Title: **QUALITY AUDIT**

**Road Safety Audit Stage 1-2, Access Audit, Cycle Audit and  
Walking Audit.**

**Proposed Clonburriss SDZ Site for Kelland Homes Ltd.**

Report reference: **1470R01**

Drawing – Landscape Masterplan – Ronan Mac Diarmada + Associates Ltd, Northern boundary.

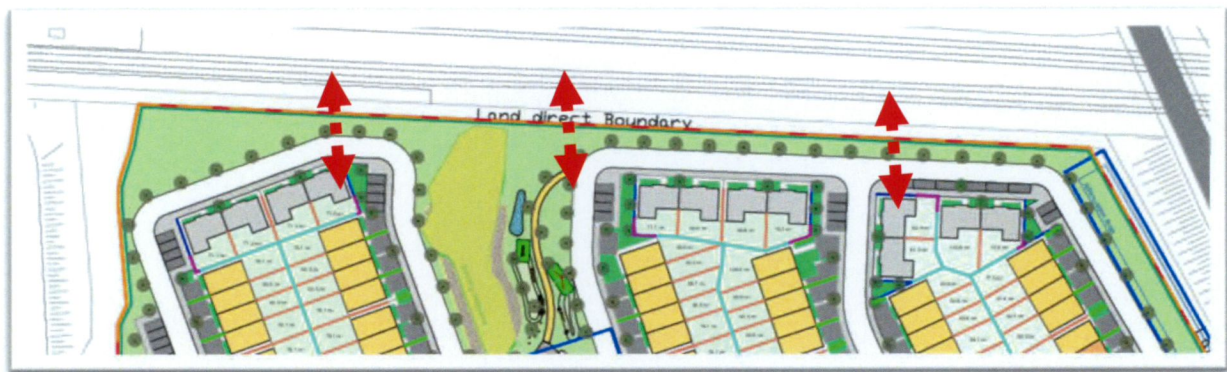
There are no proposed pedestrian or cyclist links to the path at the northern boundary of the site leading to the train station. This lack of permeability may lead to unofficial routes without hard standing which could lead to trip/slips and falls.

It is recommended that a number of pedestrian and cycle links be provided to the existing shared use path.

Paragraph No. in Quality Audit Report	Problem accepted (yes/no)	Recommended measure accepted (yes/no)	Alternative measures (describe)	Alternative measures accepted by Auditors (Yes/No)
3.1	Yes	Yes		
3.2	Yes	Yes		
3.3	Yes	Yes		
3.4	Yes	Yes		
3.5	Yes	Yes

Drawing - Landscape Masterplan – Ronan Mac Diarmada + Associates Ltd, Perpendicular parking along Road 1.

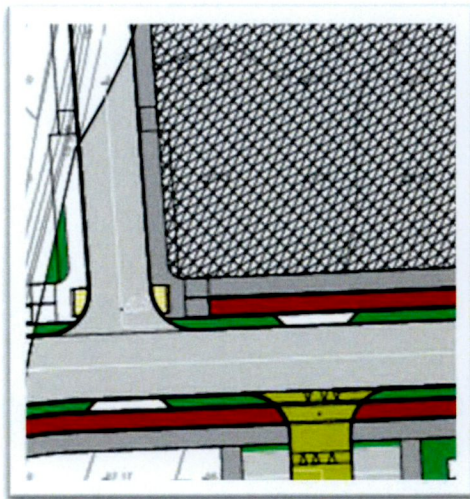
There is perpendicular parking along Road 1 with intermittent landscaped areas between parking bays. There are no other access points for pedestrians, particularly the mobility impaired including those pushing buggies or in wheelchairs to access the apartment block except at the extreme ends of the parking which may be a long way from the desire line.

It is recommended that intermittent access points for pedestrians be provided.

Drawing P200306-PIN-XX-DR-D-0001-SI P01, P&R realigned access.

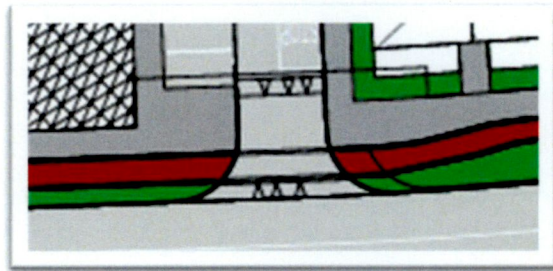
It is proposed to realign the access to the Clondalkin & Fonthill Train Station Park and Ride. It is proposed to provide a footpath only along the access road. There is an existing shared use footway/cycle track to the facility.

It is recommended that facilities be provided for cyclists along the access road.
